**JP-8 SERVICE NOTES**

*Second Edition*  
December.1982

This Notes makes First Edition obsolete and consists of two parts:

## INTERFACE BOARD OPH122A

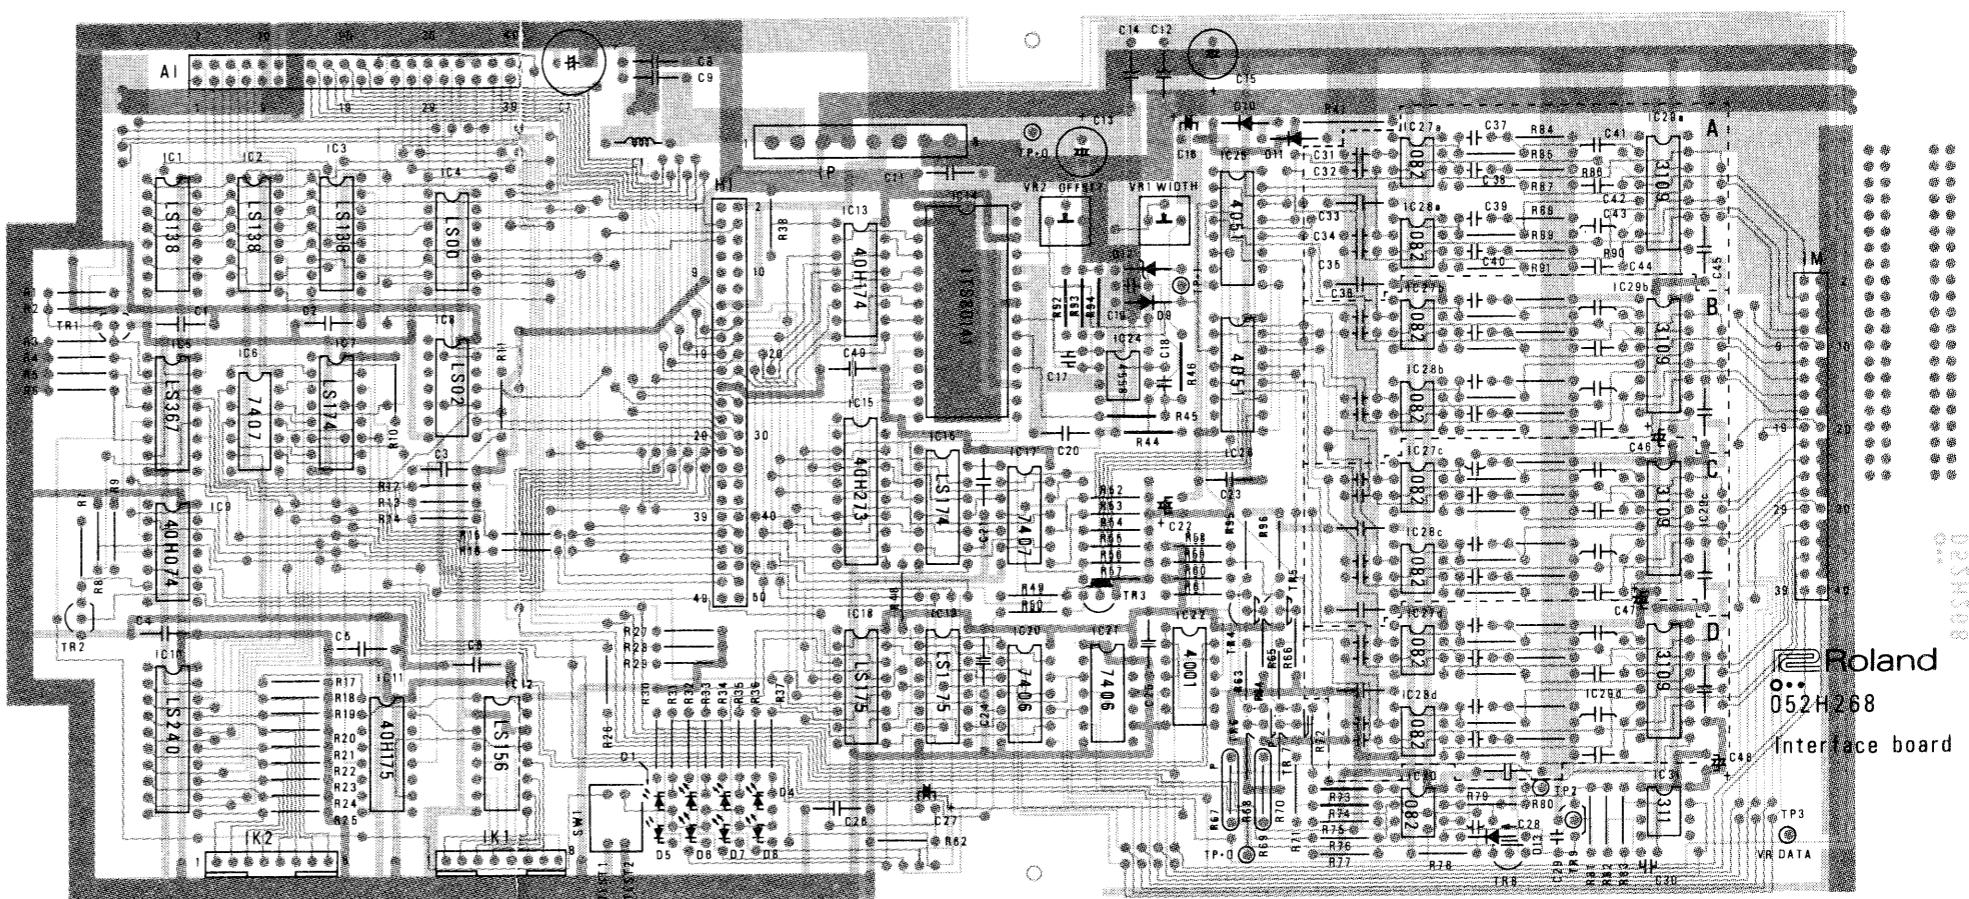
This board can replace 12-bit INTERFACE BOARD when PROMs of CPU board are of correct version. See right below.

The D/A Converter IC14 is changed from 12-bit Am6012 to 14-bit ITS80141 with this PCB version. Along with the change the following parts are also changed.

Replace existing PROMs with these PROMs.

Adjust DAC circuit, referring to "4. DAC" on p.25 of this book.

**MODULE CONTROLLER BOARD SN 202100 and UP****OPH123A (149H123A) (pcb 052H269)****IMPORTANT**

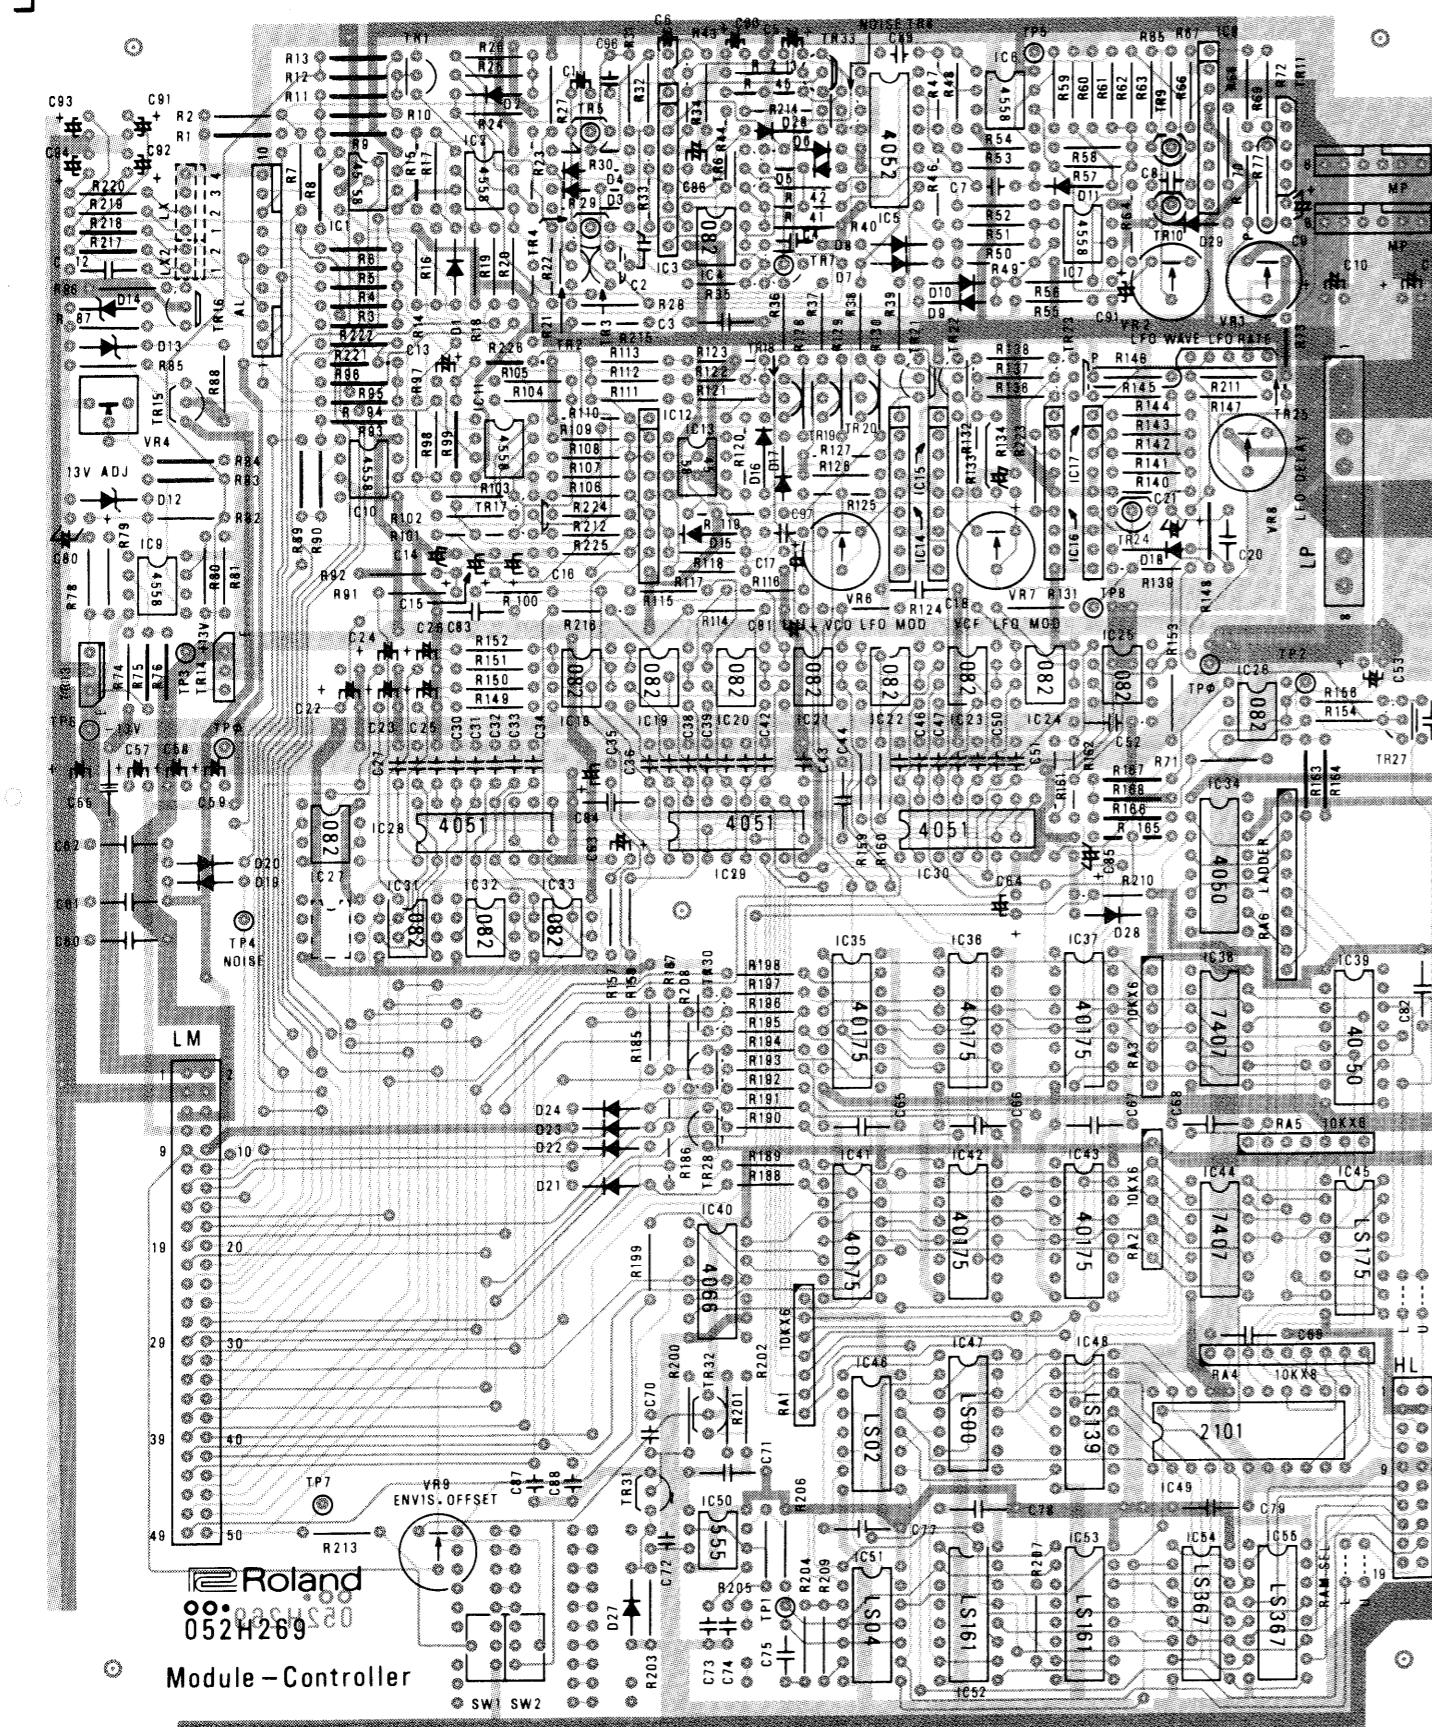
**7. Add D29 and C95 to +B pin of IC7 (S, 36) to stabilize the supply voltage****8. Add RC filters on EXT CV lines (L, 43; S, 41; E, 35; D, 33)**

Apply a ground to pin 5 of IC2 through R21, previously -15V. Change resistors values in this section

To have the same volume changes in VCO-1 and VCO-2 sounds, that is, the change in volume of VCO-1 when SOURCE MIX is being rotated toward VCO-1 is the same as that of VCO-2 when S.M. being toward VCO2.

Add C97 across pins 1 and 2 of IC13  
To eliminate click noises at positive or negative going transient.

**11. Add TP-8 (Q, 36-37)**

## IC49 OF MOD CON BOARD (MODIFICATION ON CPU BOARD)

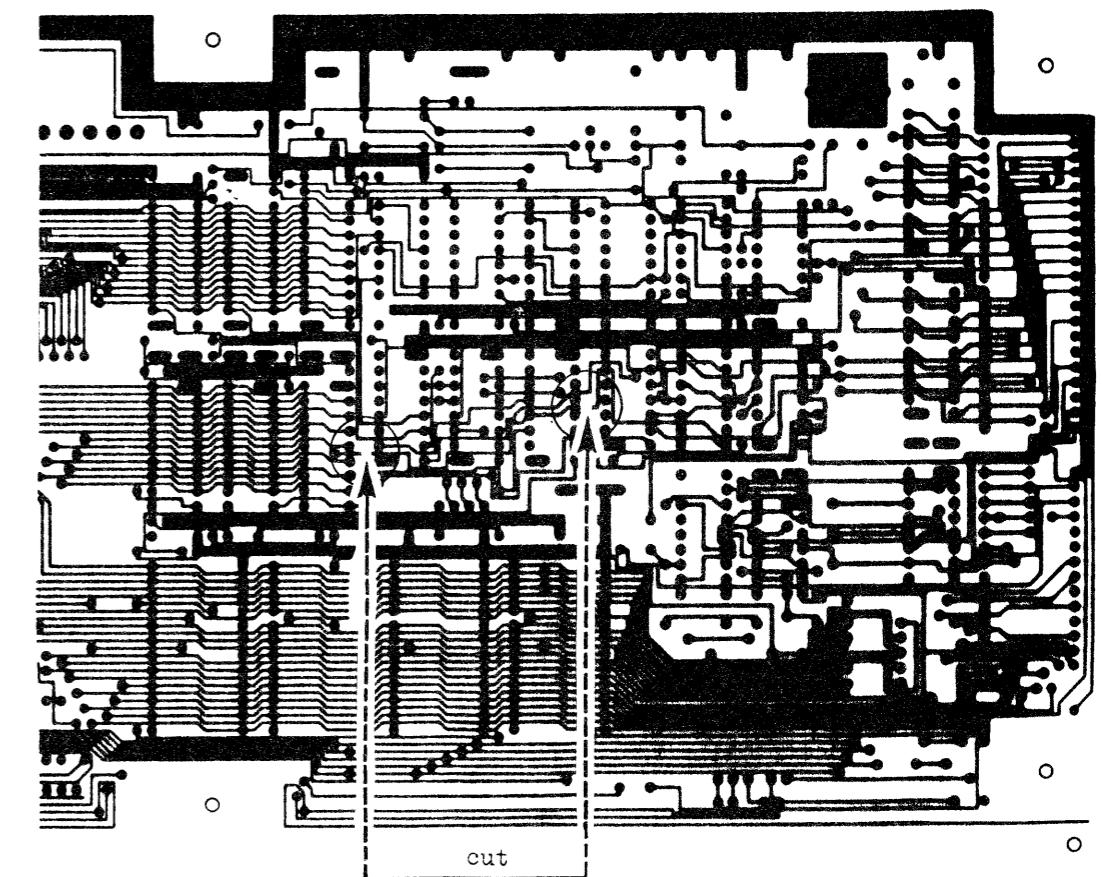
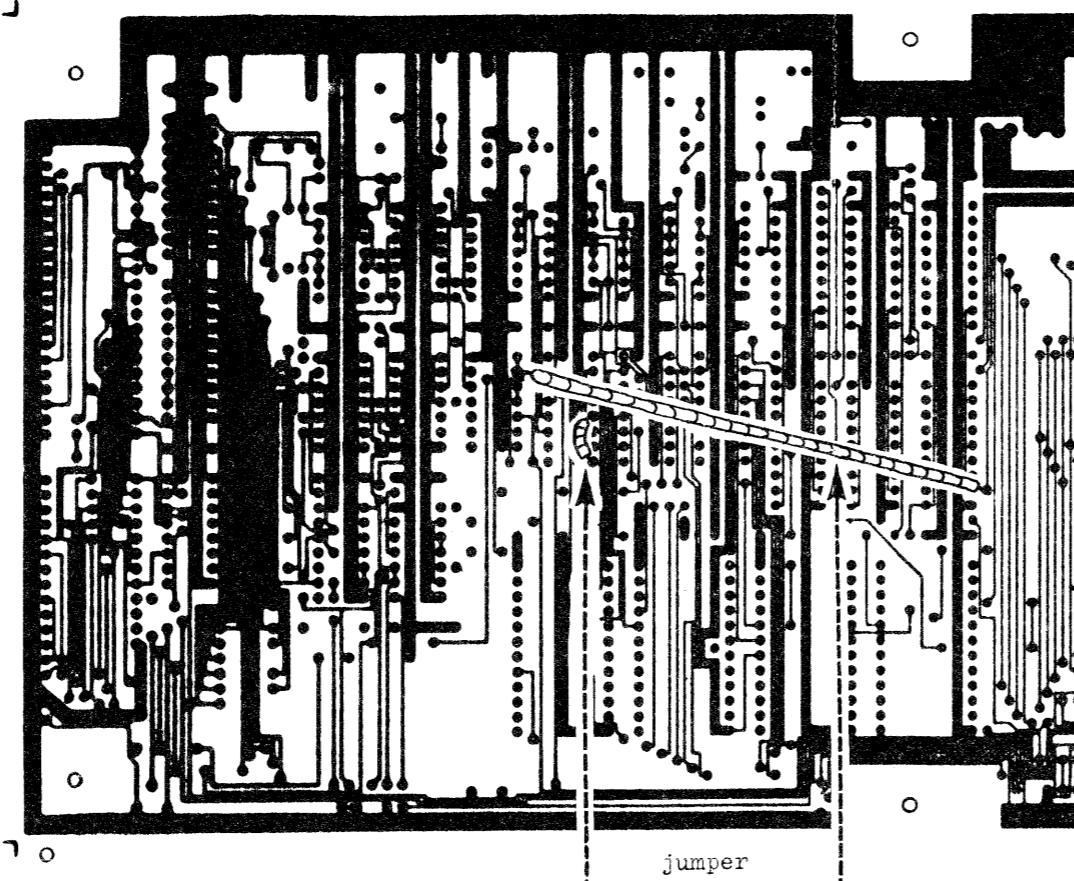
Check IC49 on the both PCBs (being replaced and replacement) for name. If 2101 is on the existing PCB and 5101 on the replacement, take the modification illustrated below.

Below, two minor modifications (independent of RAM change) are also indicated:

Reconnection of IC37 and addition of 10UF at IC30  
pin 8

This modification has no adverse effect on 2101.

MODULE CONTROLLER BOARD

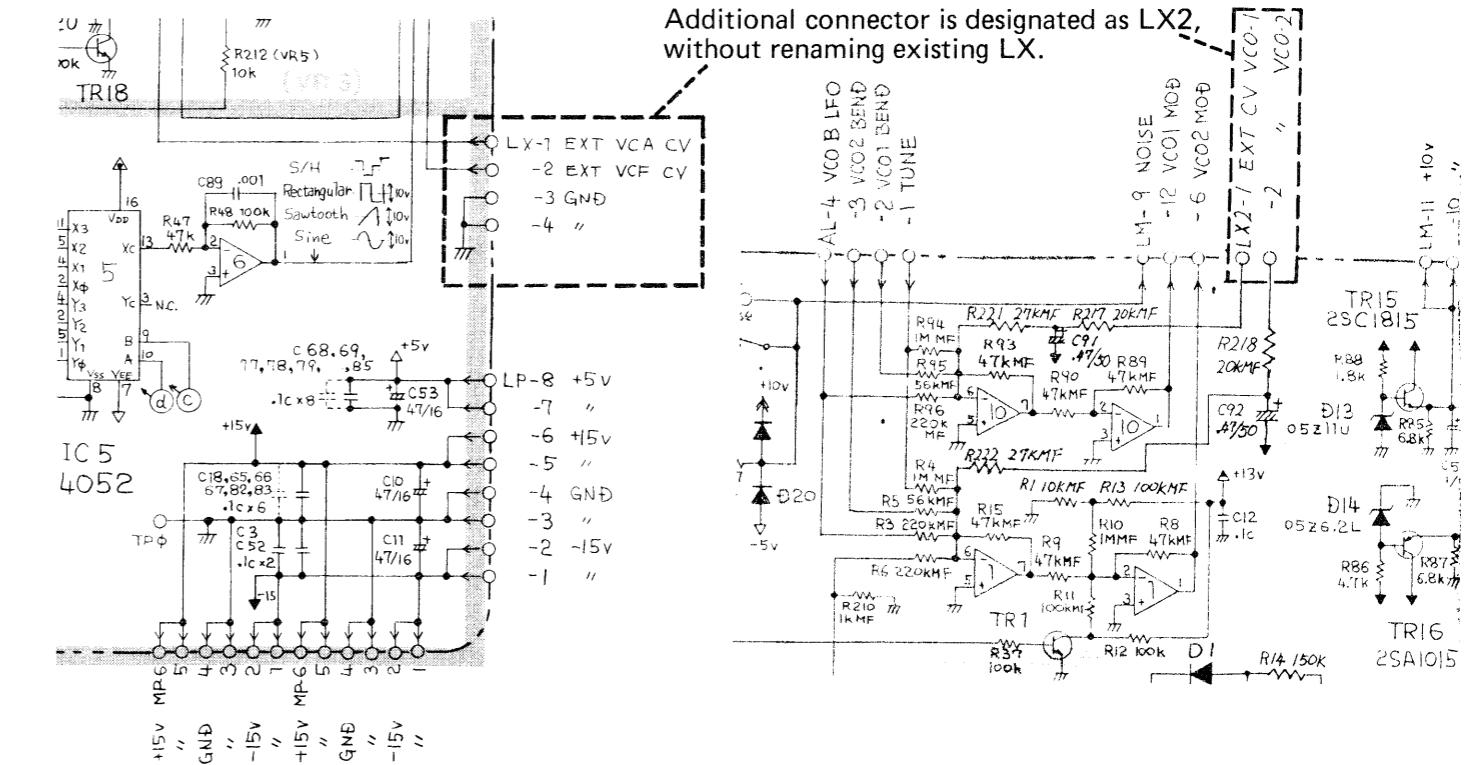
Additional connector is designated as LX2, without renaming existing LX.

PATTERN-CUTS & SURFACE-MOUNTINGS  
ON MOD CON

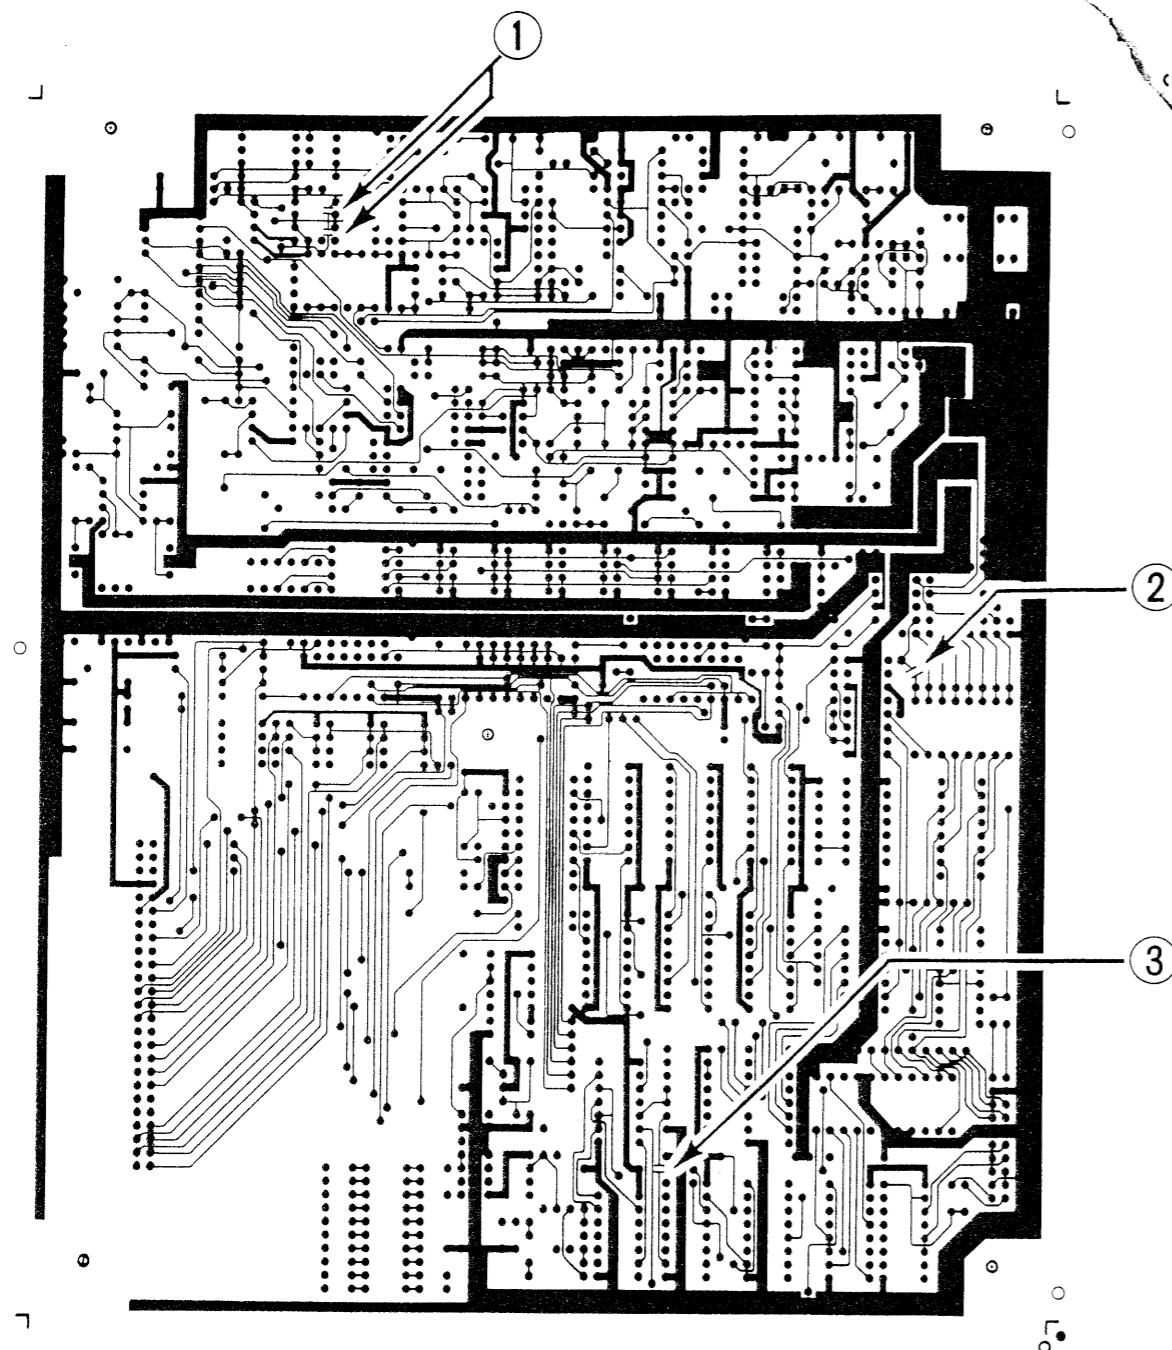
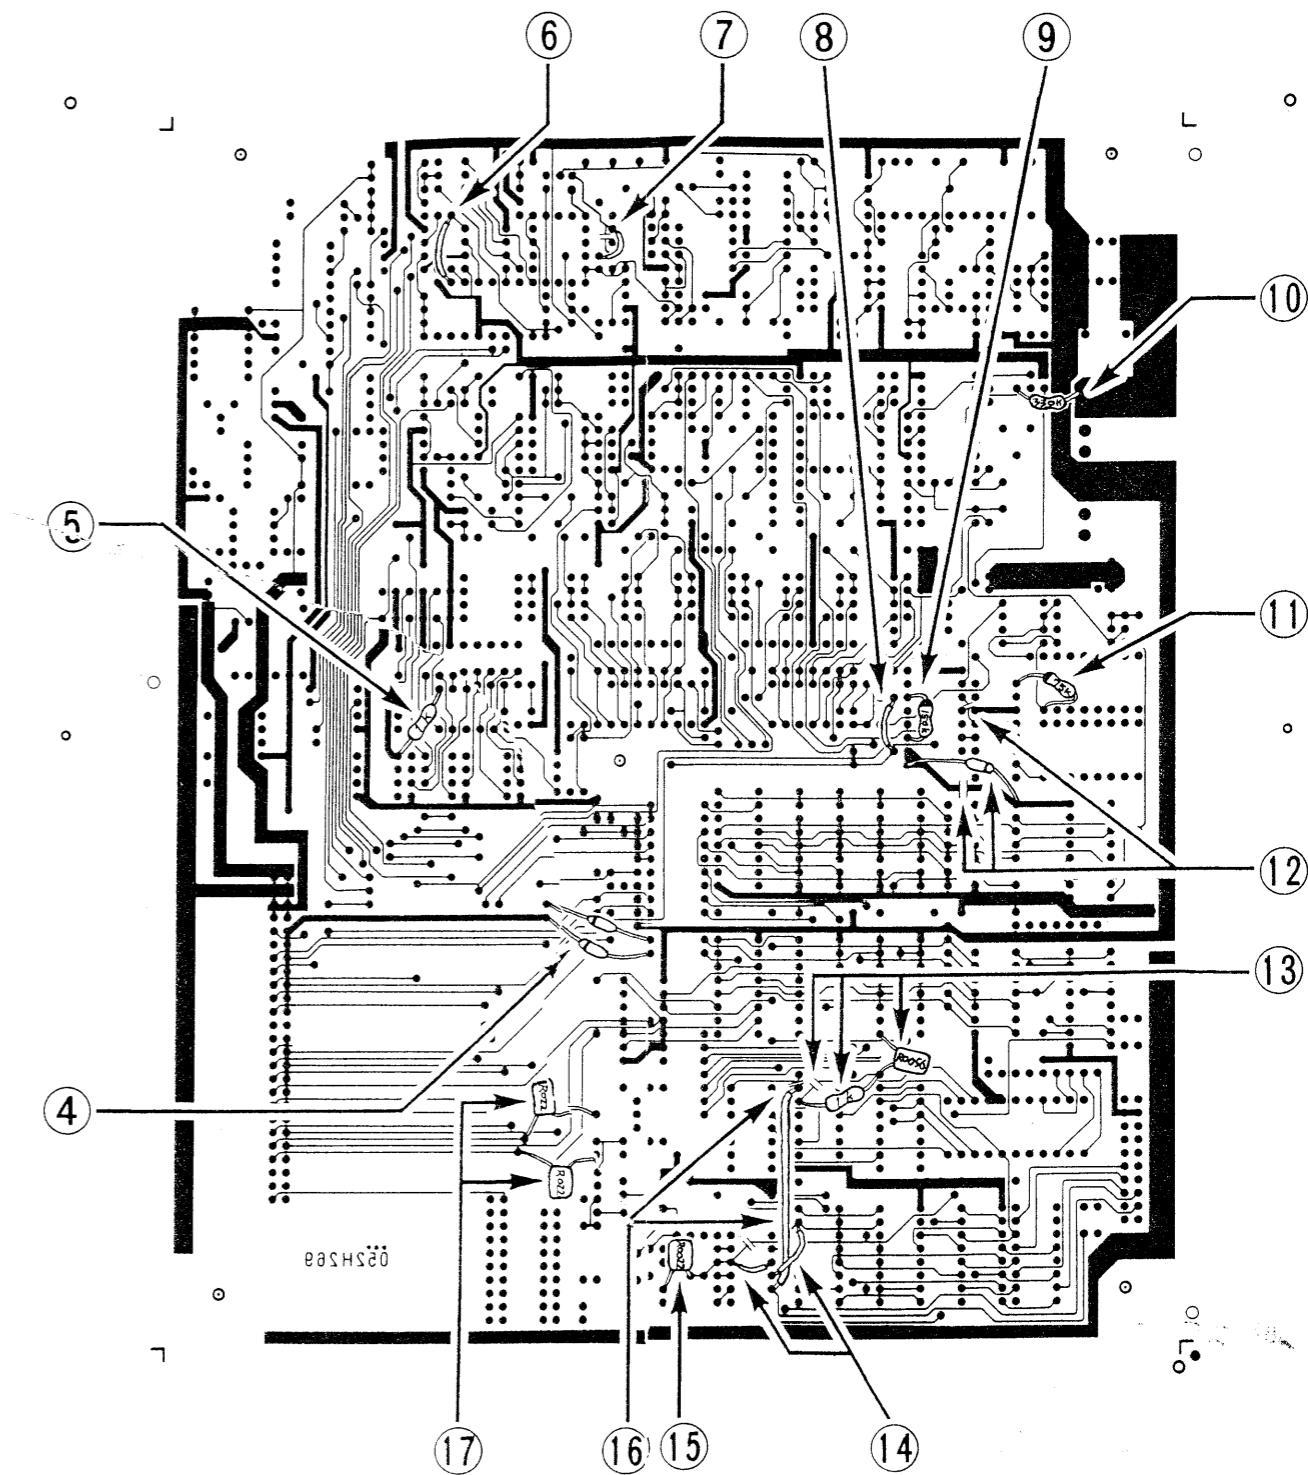
Listing below are descriptions of surface mounting, jumper wire, and conductive foil cut made on the MOD COM boards up to the abovementioned serial numbers, shown on the next page.
